Renault Megane I **Model year: 1996 – 2002** **With air conditioning system**

Noises in recirculation mode

Bulletin

Drawing 1

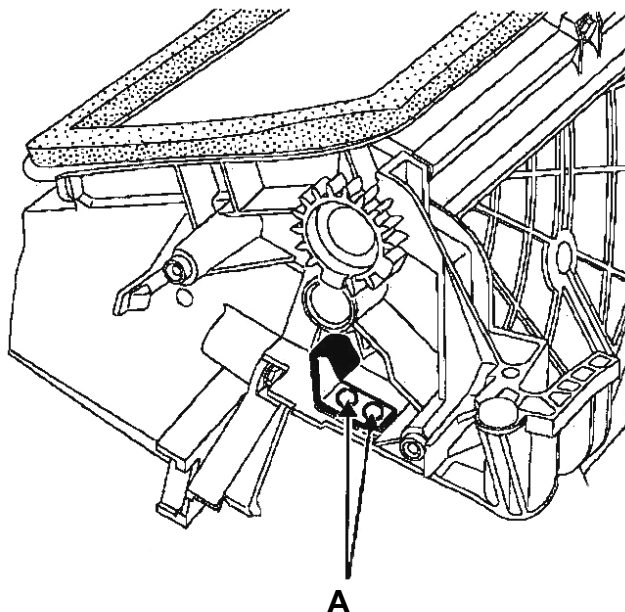
If with these above-mentioned vehicles noises occur in the dashboard area in recirculation mode, the cause could be damaged teeth on the drive pinion of the recirculation flap. A break in the mechanical stop can damage the teeth on the drive pinion. To eliminate the problem, the recirculation flap and drive pinion have to be replaced.

In addition, a new mechanical stop has to be self-made from a metal plate 2 mm thick and 10 mm wide (see drawing 1). The mechanical stop is attached to the housing of the recirculation flap using two rivets (drawing 2). There is quite a considerable amount of work involved, exactly how much depends on the engine version.
